This procedure details the objectives, test and documentation requirements to implement the isolation device testing program.

The objective of these tests is to demonstrate the ability of the isolation devices used in the SFAS modules and system to withstand the application of fault voltages and currents to the Non-IE side of the isolator.

SIZE A	FSCM NO. 02750	DWG NO. KAM7315
SCALE	REVISION A	SHEET 2

FIGURE 7

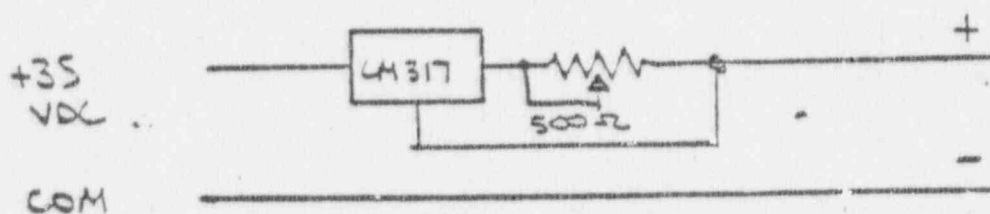
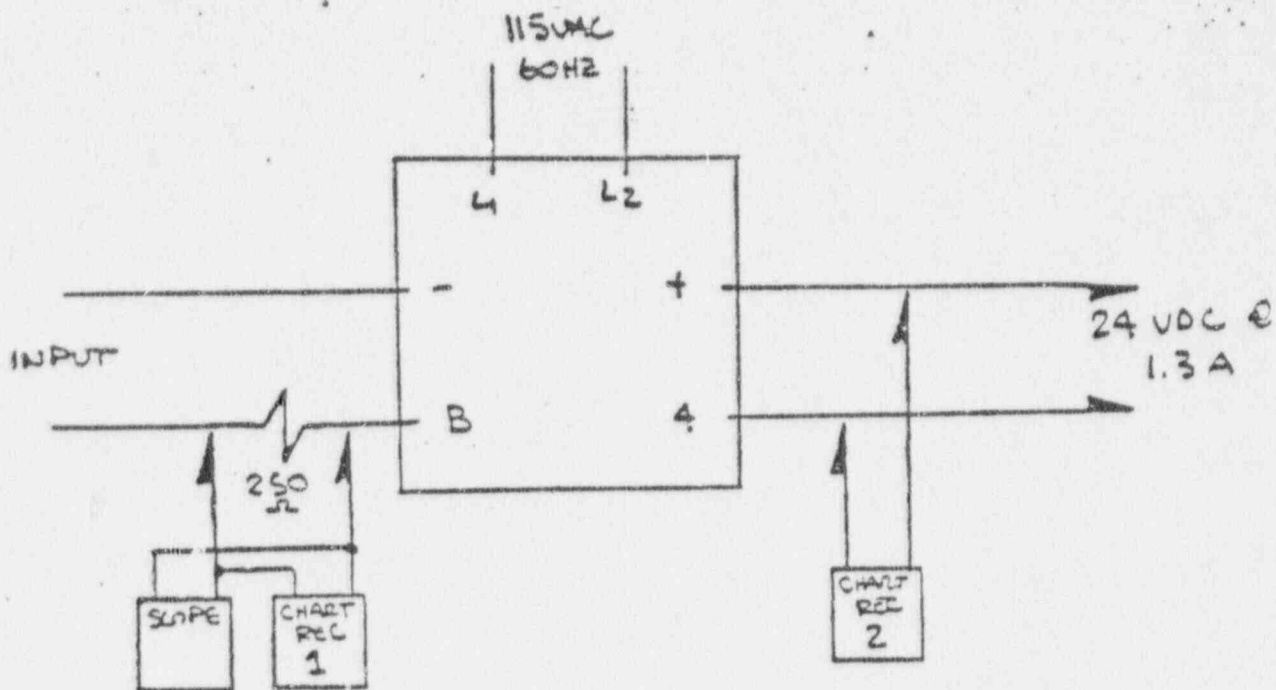
LTR	DESCRIPTION	DATE	APPROVED
-	REV'D ON C/N 51958	2-29-80	am
A	REV'D PER C/N 52009 SHTS 2,3,4,9,10,11,12,13. 172VDC WAS 120/125VDC.	3-20-80	K. RICH
B	REV'D PER C/N 52059 P5.2.4 47.25 WAS 47.5 P5.2.10 52.75 WAS 52.5	4-3-80	K RICH
C	REV'D PER C/N 52306. ADDED 'TYP INPUT CRT' TO FIG 6,7,8	6/25/80	Wc

TYP INPUT CKT
